# 45 McLaren St

## North Sydney

Response to Council RFI

February 2024

### Ground

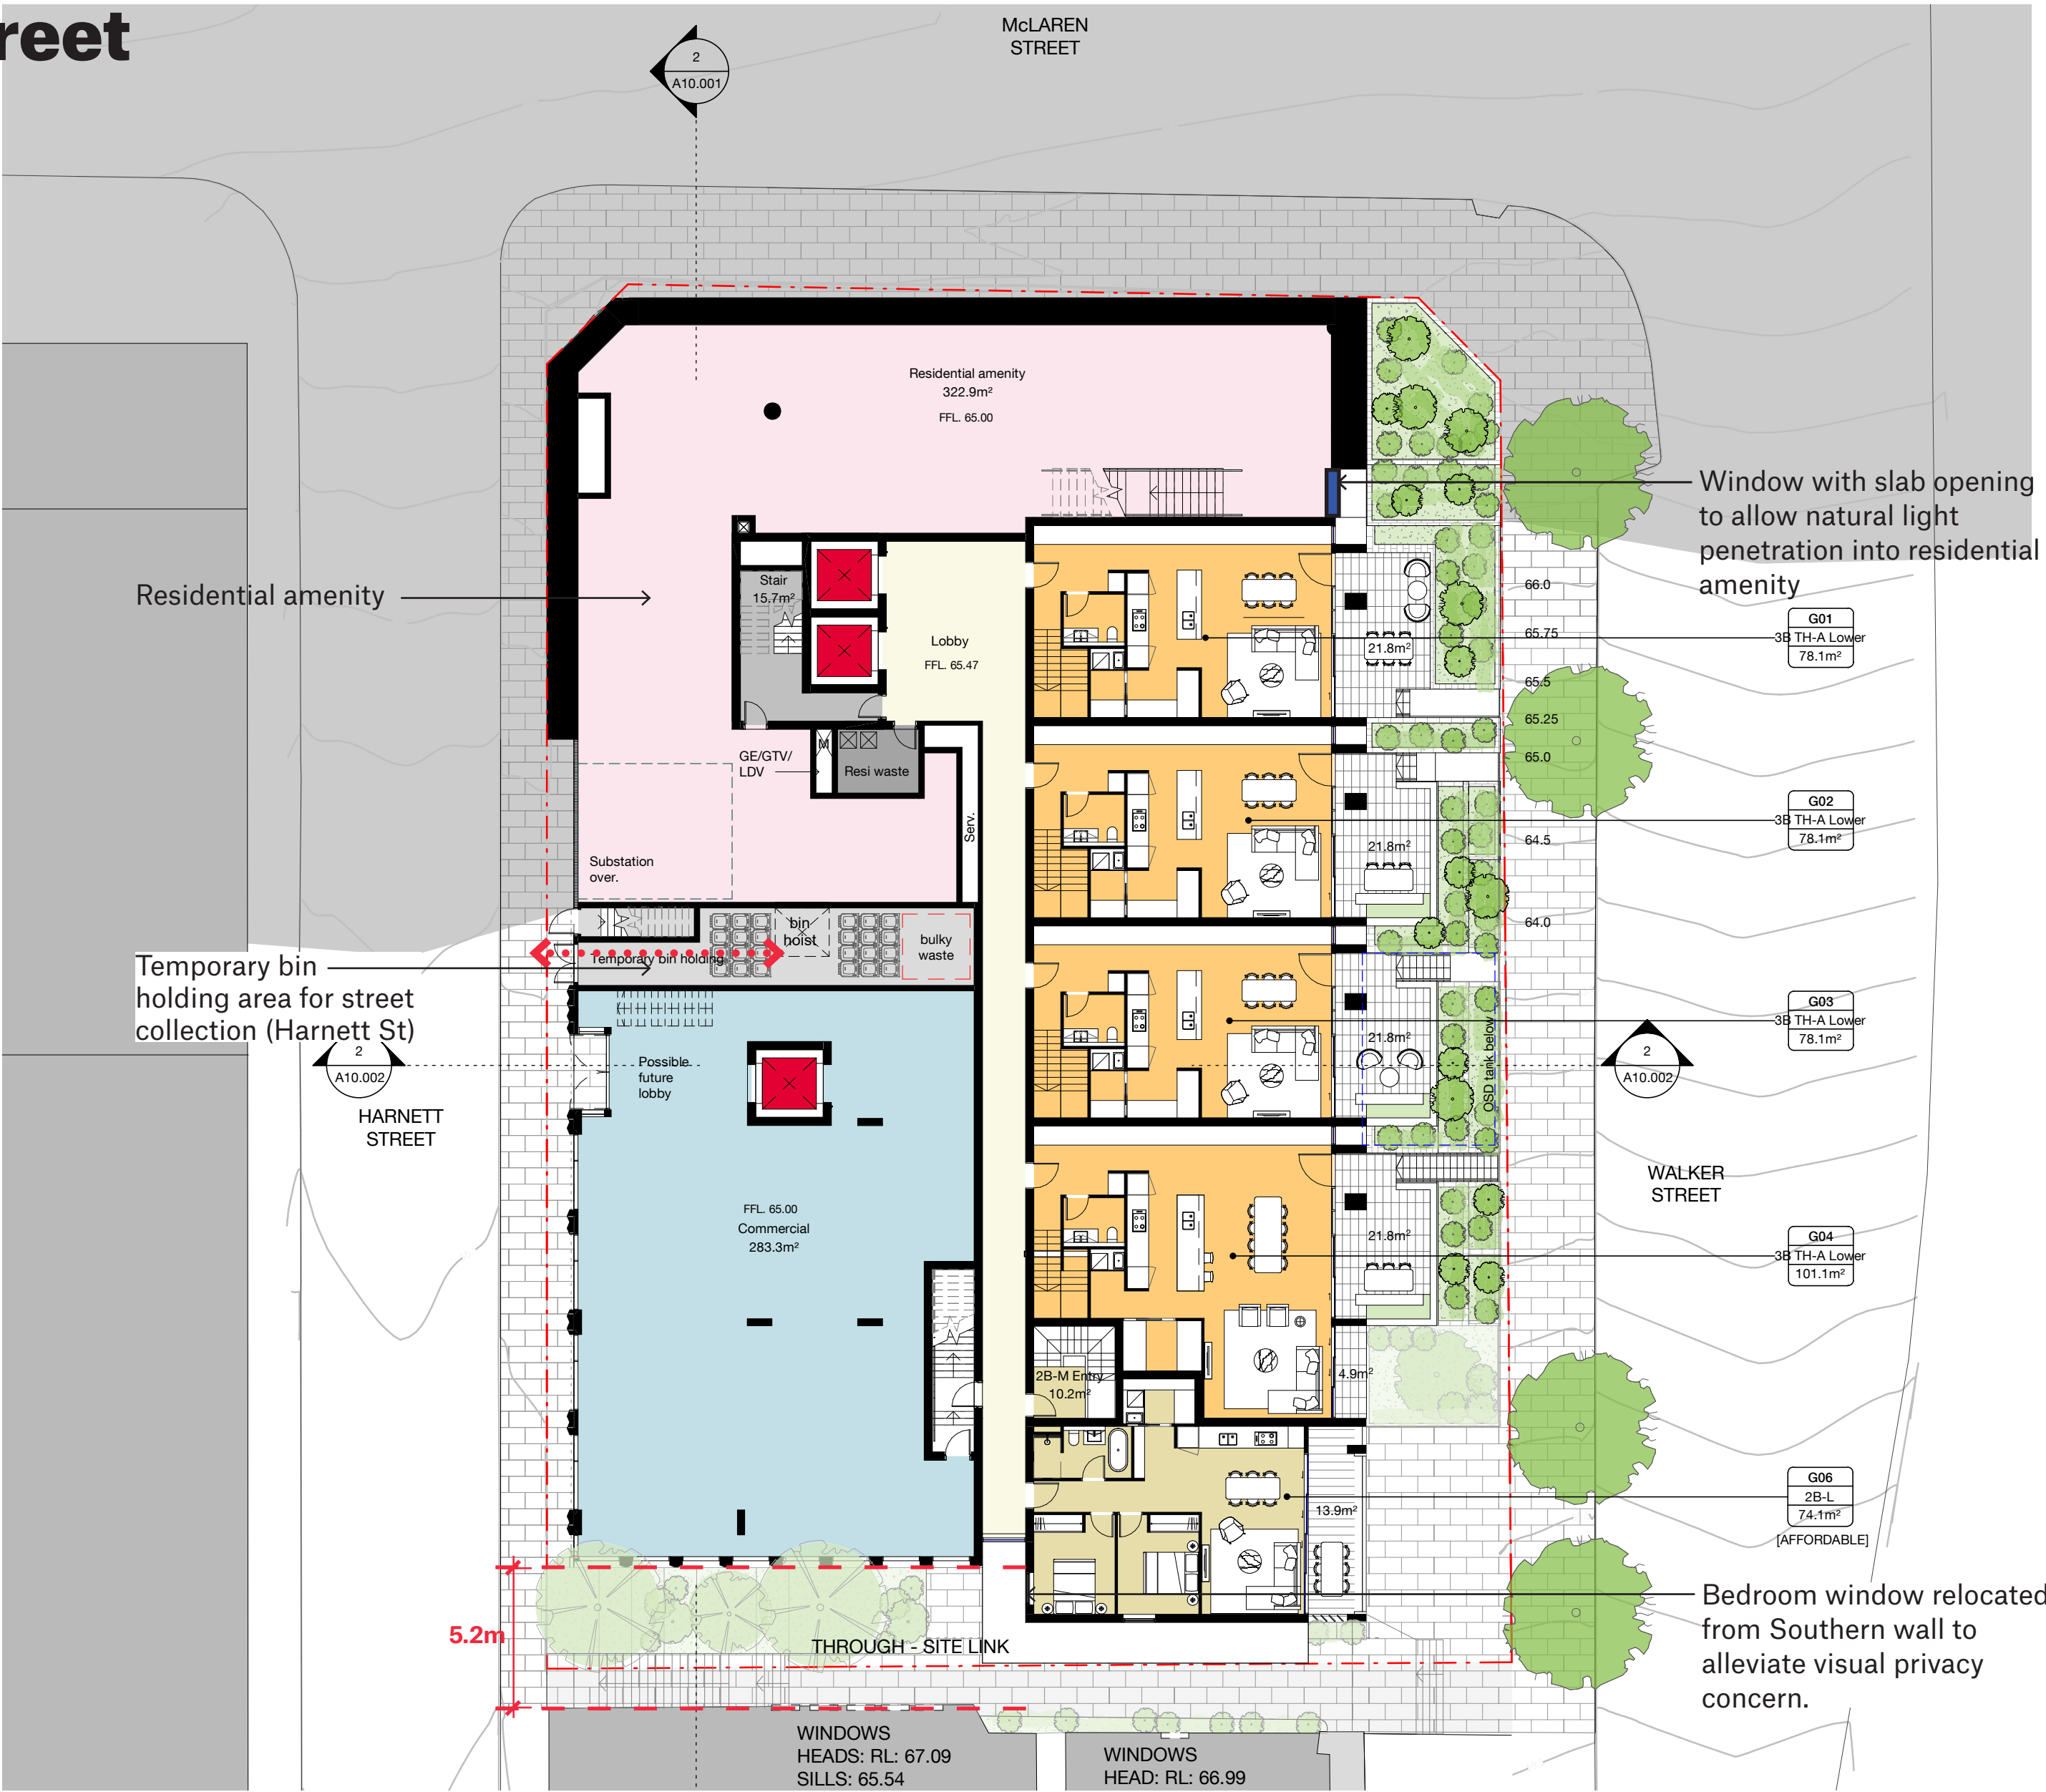
*The **residential waste bins** need a **temporary bin holding area for collection from the street** within 2 metres of the property boundary. The holding bay must be large enough to fit 24 x 240L bins (compacted waste) and bulky waste material and be consistent with NSDCP 2013 Appendix 3 – Waste Management Guide, for high-rise, residential and mixed residential/commercial buildings.*

- Temporary bin holding area on Harnett Street, enabling street collection. Bin hoist connection from loading dock.
- Residential amenity room relocated to residential floors. Slab on Upper ground has been cut back to allow natural light penetration.
- One of the bedroom window to SE corner apartment is relocated to face West to minimise visual privacy concern with heritage dwelling adjacent.

**Pictured**  
UG plan with new awning extent

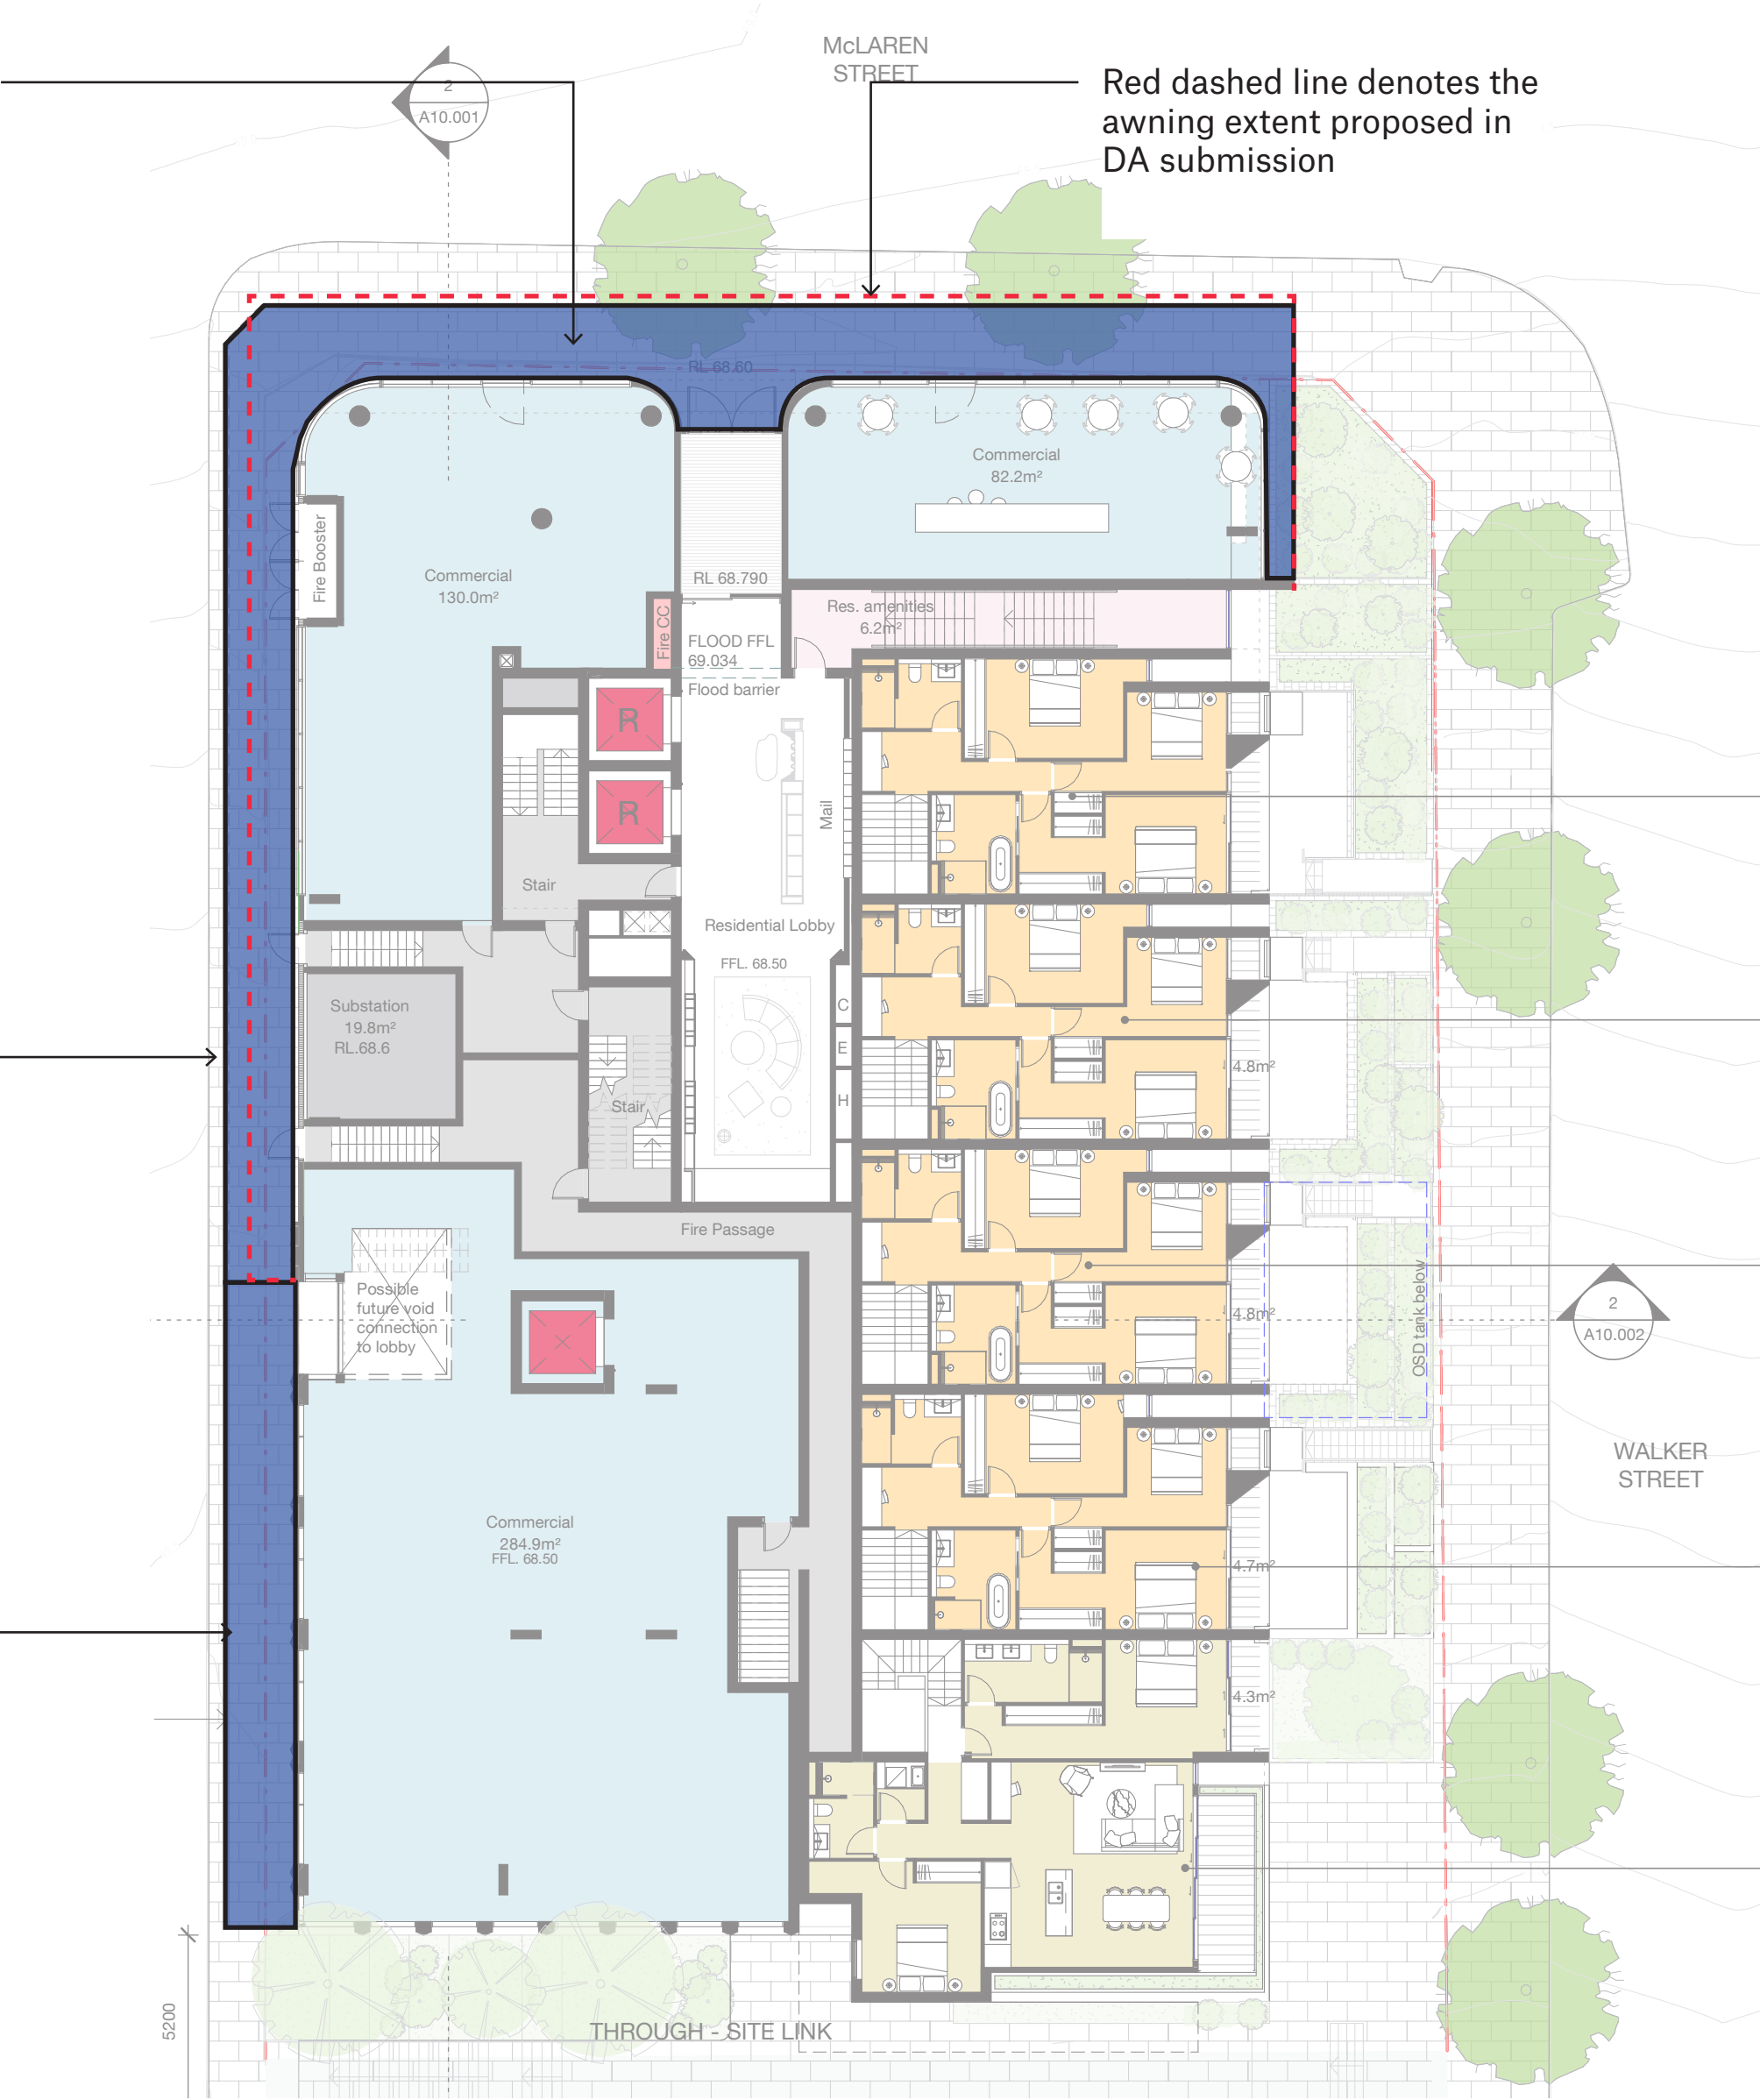
***Awnings** are to be provided in **compliance with the DCP***

The revised awning will feature a minimum width of 2000mm, ensuring a setback of at least 600mm from the kerb along Harnett Street and a minimum setback of 1.5m along McLaren Street to accommodate street trees.

Revised awning on McLaren Street will be 2250mm deep, ensuring 1.5m setback from kerb is allowed for street trees.

Awning on Harnett Street to be 2000mm deep with min. 600mm setback from the kerb.

New extent of awning shown in blue.
